# **Product Change Notification**

Product Change #: 331

Description of Change: The tab gate is being changed to a sub gate and the geometry is being updated to accommodate this. Part models are being updated to show the VP logo.

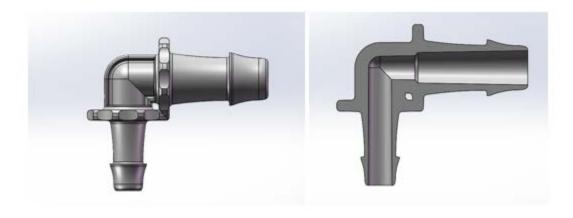
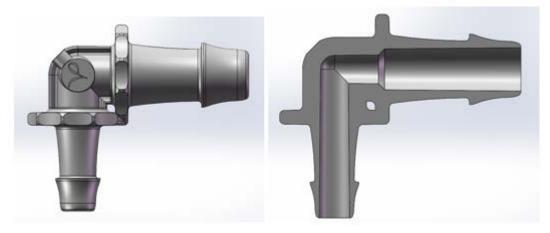
Figure 10 - L070-055 post-change. This change includes the addition of a tab in order to accommodate the sub gate which also cuts small part of rib away, the I.D. has slightly more draft from .45 degrees to 2 degrees, and the I.D.'s step also has slightly different geometry than original. The VP logo was also added.
